RotorSport UK Ltd Service Bulletin (Permit)

Title: Cavalon fuel tank/body seal		
SB-118 Iss1	Related documents Modification: MC-357 CCAR No.: CCAR-063	Compliance Category: OPTIONAL or RECOMMENDED or MANDATORY
Applicability		
Aircraft type & model: Cavalon	Aircraft serial Nos. affected: RSUK/CVLN/001 to RSUK/CVLN/021	
The maintenance manual to be referenced is this stated or subsequent issue.		RSUK0288 Iss:6
<p>This form is the response from RotorSport UK Ltd either against a problem found in the product in service requiring a containment or rectification action, or as service information for aircraft modification incorporation. For help, contact RotorSport on 44(0)1588 505060, or email compliance@rotorsport.org.</p> <p>The technical content of this document is approved under the authority of the UK CAA Design Organisation Approval Ref: DAI/9917/06</p>

AG-SB-2016-06-B-EN – Cavalon fuel-tank inlay ring

Fig. 1: Fuel filler

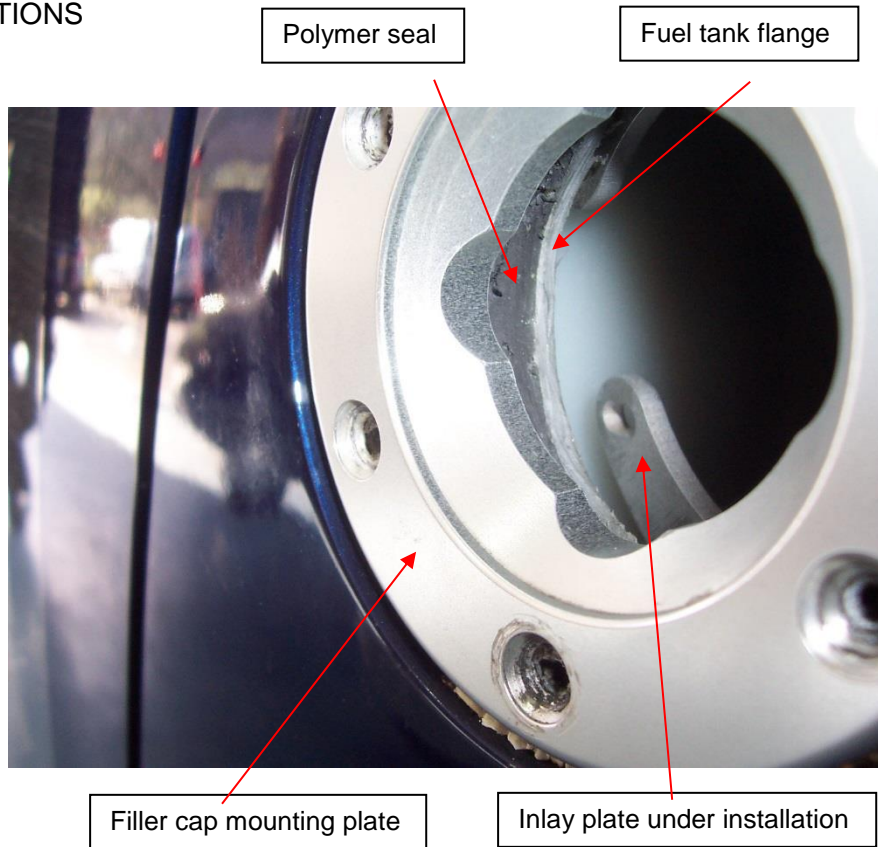
At the affected Cavalon an aluminium “inlay ring” is placed inside the filler neck and by means of a new rubber seal combined with longer fuel filler mounting screws allows the fuel tank flange to be pulled uniformly against the body – squeezing the new rubber seal between to ensure a perfect sealing (see fig. 1).
